Application No: DEV2022/1295

Site Location: 905 Flagstonian Drive, Flagstone

Application Description: Development Permit for a Material Change of Use for Child Care Centre and Indoor Sport and Recreation (Swim School)

Subject: Response to EDQ's Further Issues – Traffic Matters

Amended Development Plans

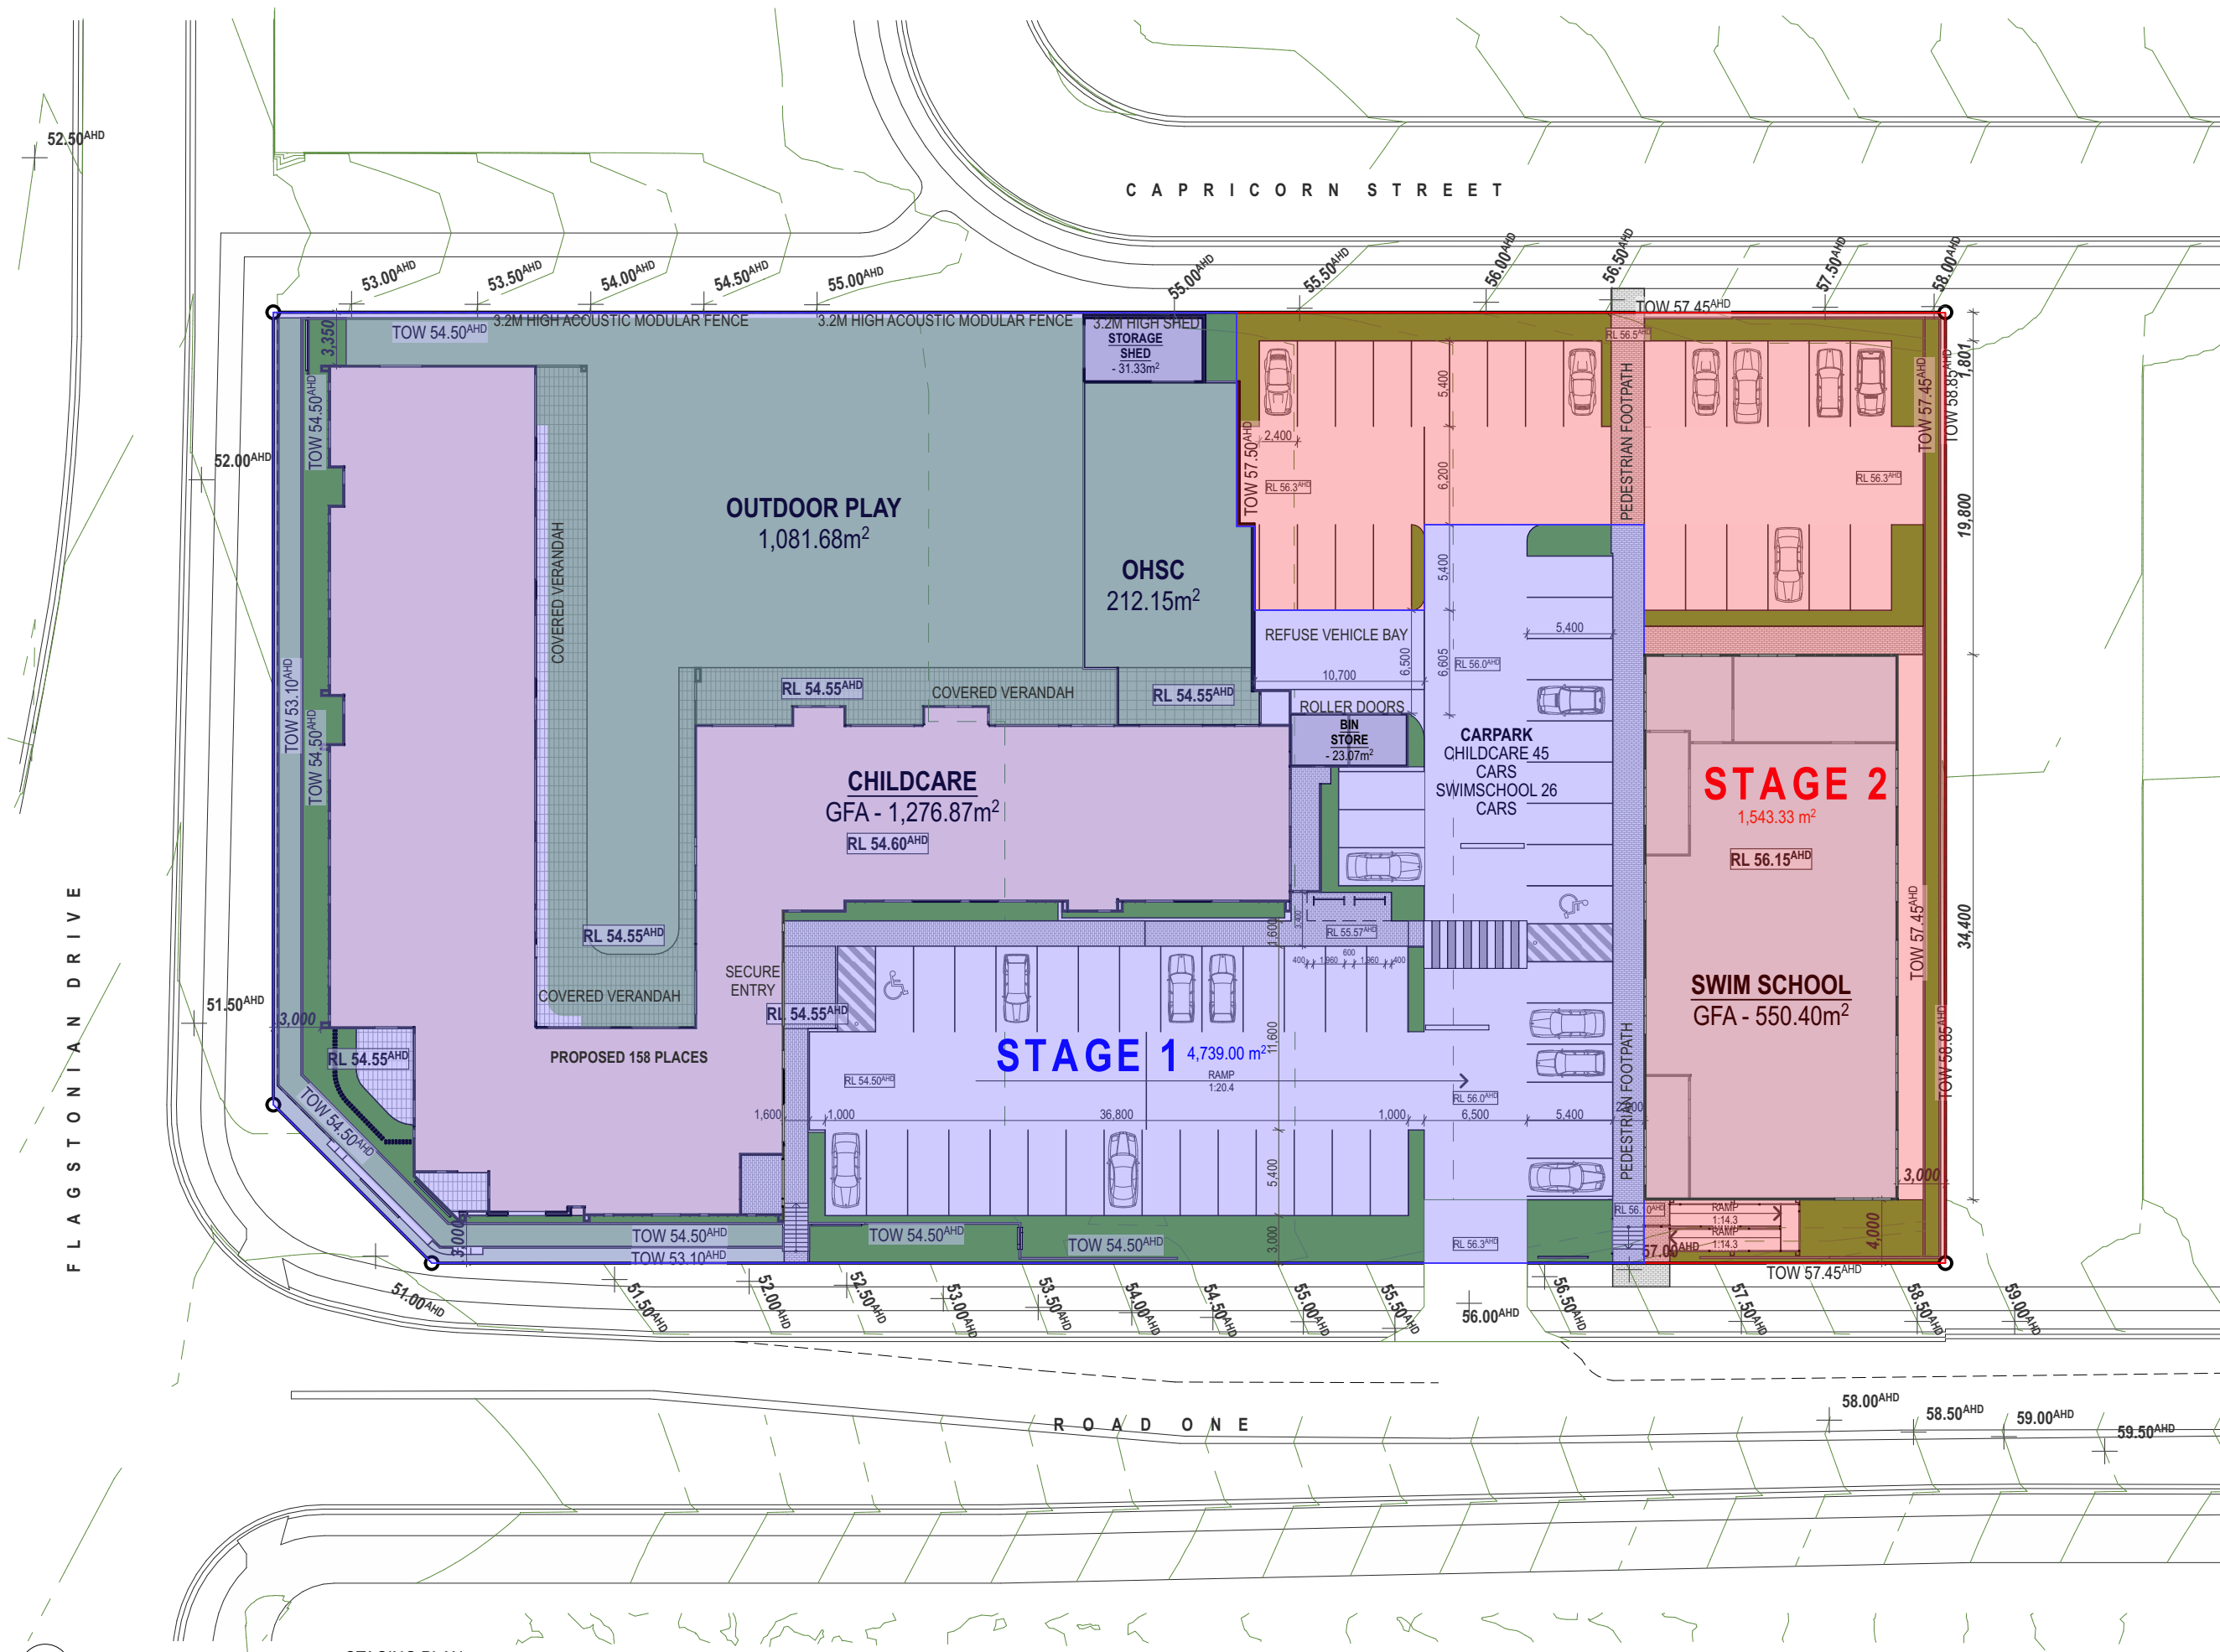
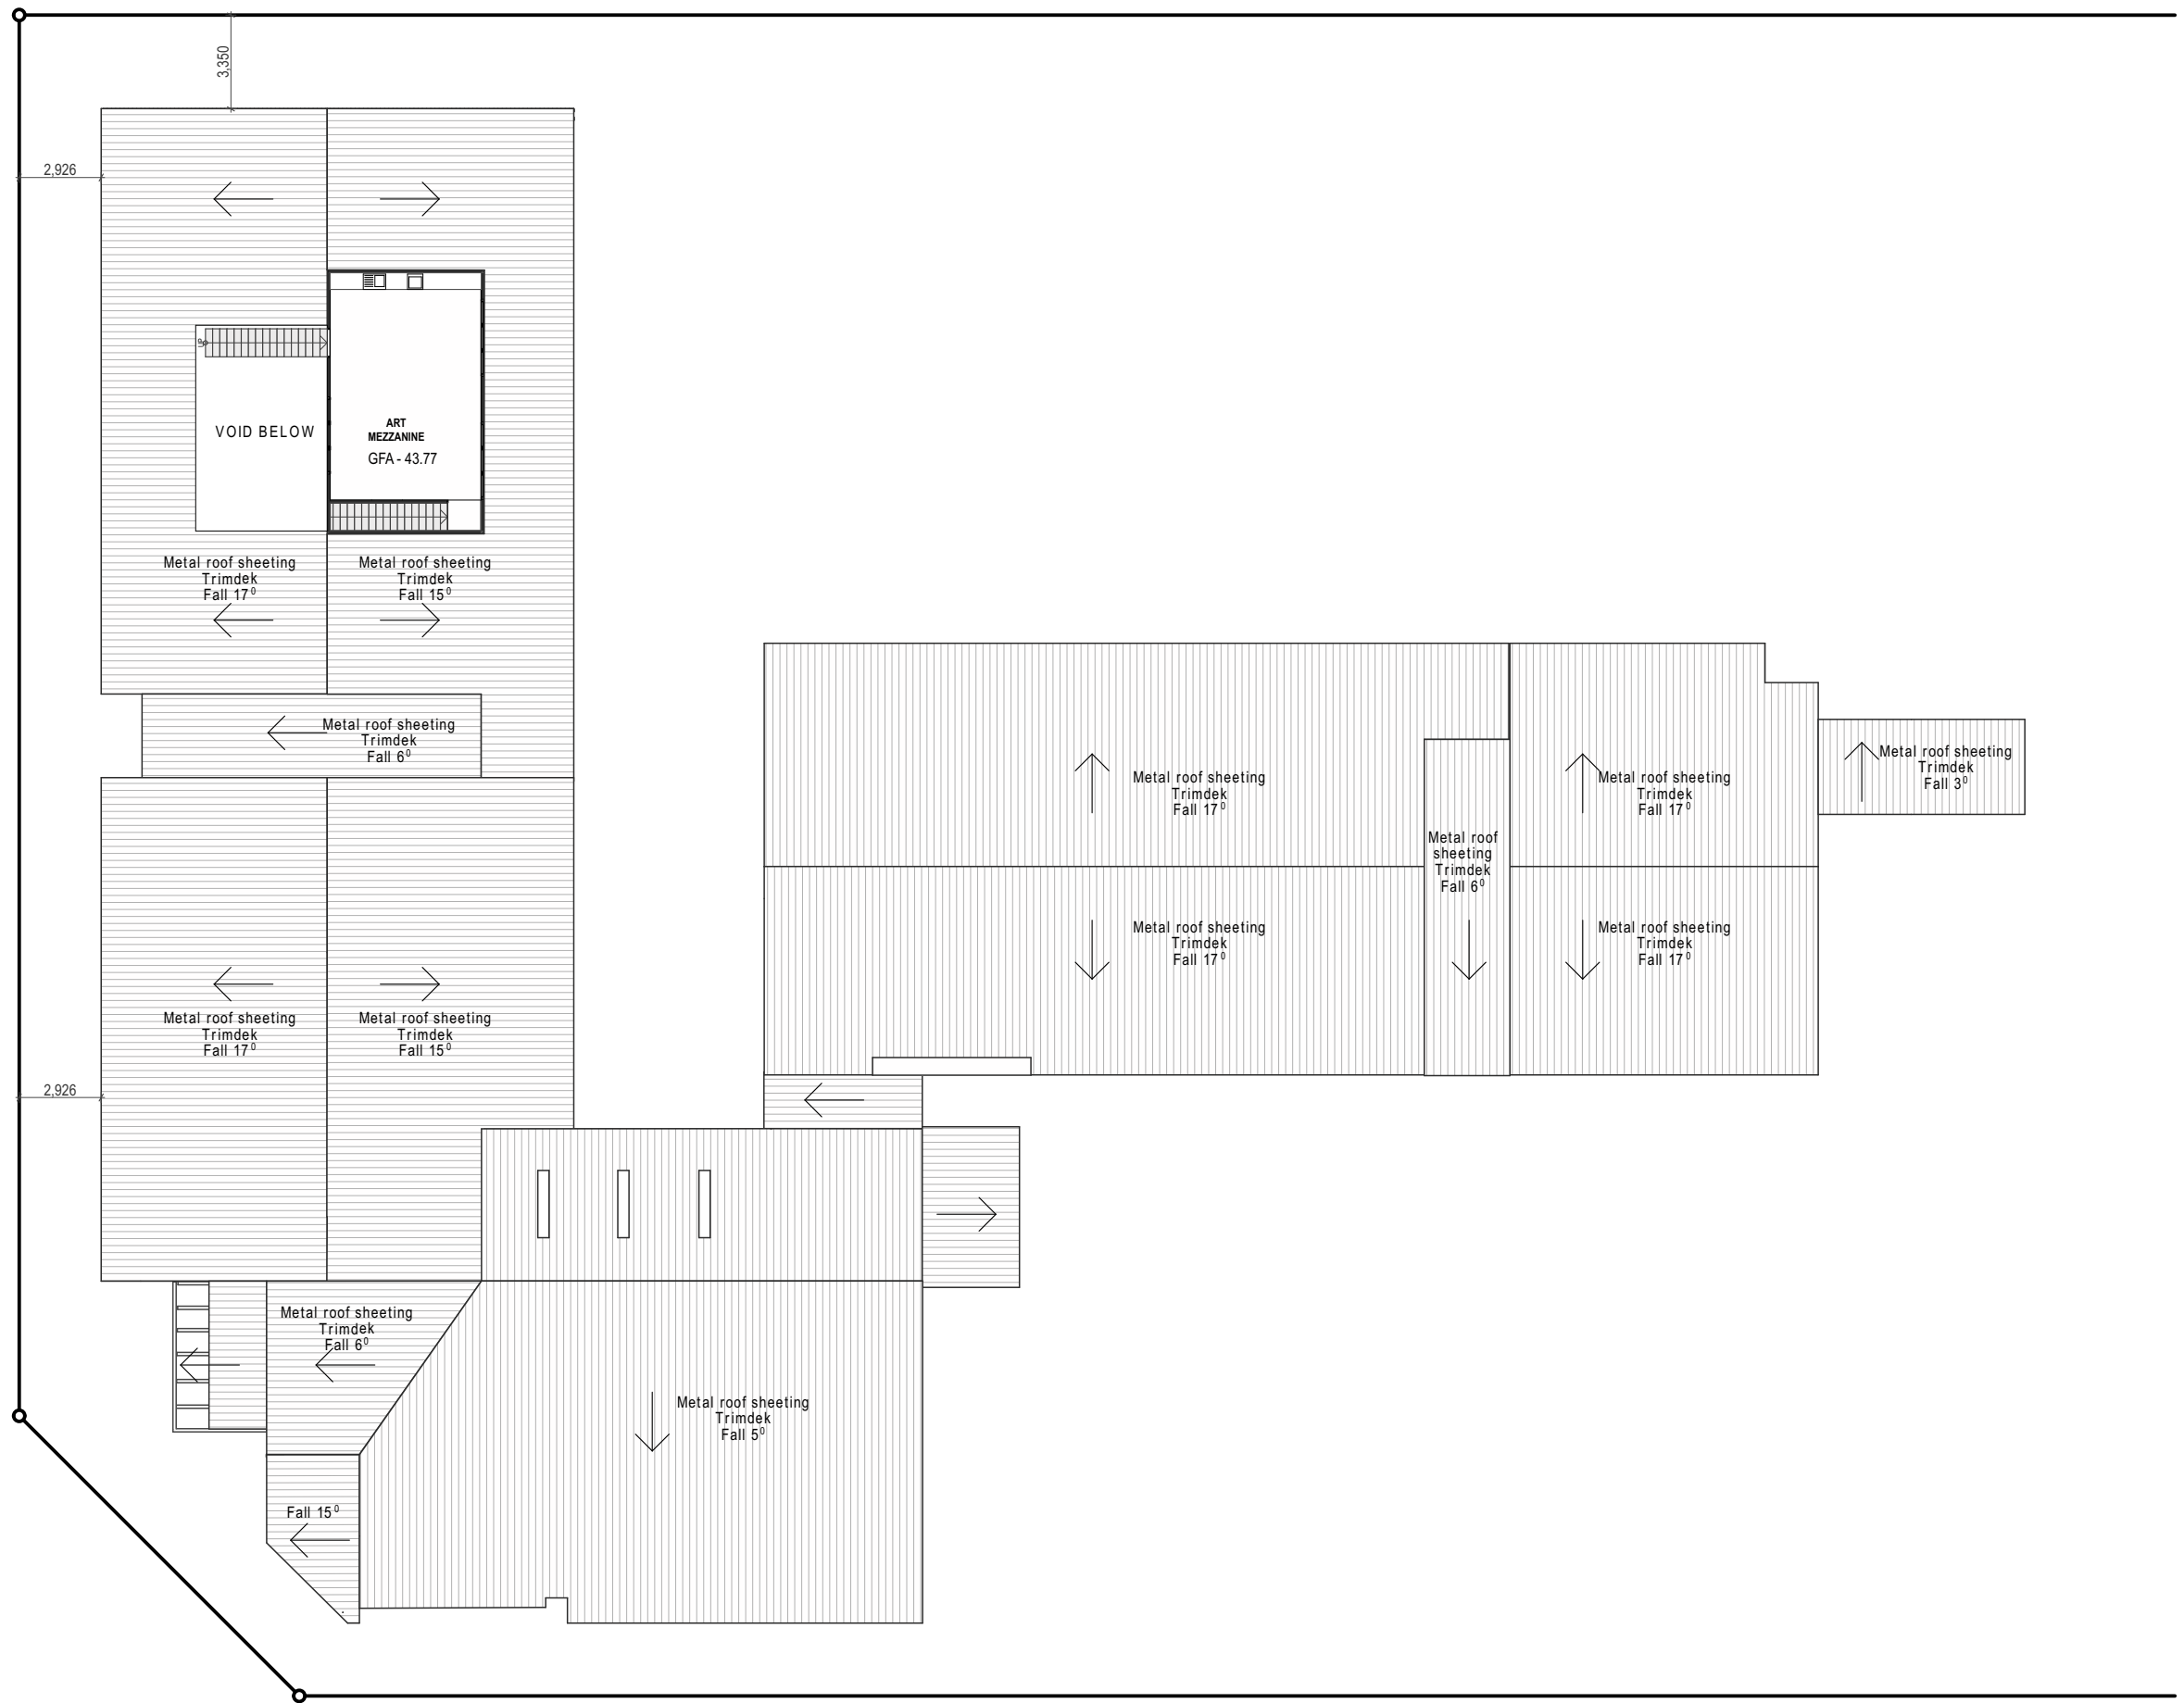
a. Provide an appropriately designed safety crossing (i.e. 'wombat' crossing), to directly connect the internal pedestrian movement pathways of the swim school to the child care centre, over the internal carriageway.

b. Provide an appropriately designed pathway connection to the existing pathway on Capricorn Street.

a. Submit amended plans to show the provision of 14 bicycle spaces. Note: bicycle parking must not detract from the landscaping provision.

In accordance with the design in Austroads Guide to Traffic Management Part 8: Local Area Traffic Management, a 'wombat crossing' has a minimum width of 6m, i.e. 3.6m crossing width plus minimum 1.2m ramp width on each side. The provision of this treatment would require the removal of at least three (3) car parking bays, and is therefore not a feasible option in this instance.

As an alternative, as shown in the plans included as **Attachment 1**, a zebra crossing across the main parking aisle (linking the swim school and the childcare centre) is now proposed. This crossing is aligned with the shared area adjacent to the accessible parking space. Speed bumps are proposed on the approaches to this crossing, to control vehicle speeds in proximity to the crossing.

It is however recommended that the landscaping on the western side of the crossing be limited to less than 600mm in height, to ensure visibility between approaching vehicles, and pedestrians approaching this side of the crossing. This is a detailed design issue which could reasonably be addressed in response to a condition of the approval.

As shown in the plans included as **Attachment 1**, a pedestrian pathway connection is now shown to the existing pathway on Capricorn Street.

As shown in the plans included as **Attachment 1**, two (2) bicycle parking racks accommodating at least 14 bicycles are now proposed at the south-eastern corner of the childcare centre building, to the west of the zebra crossing.
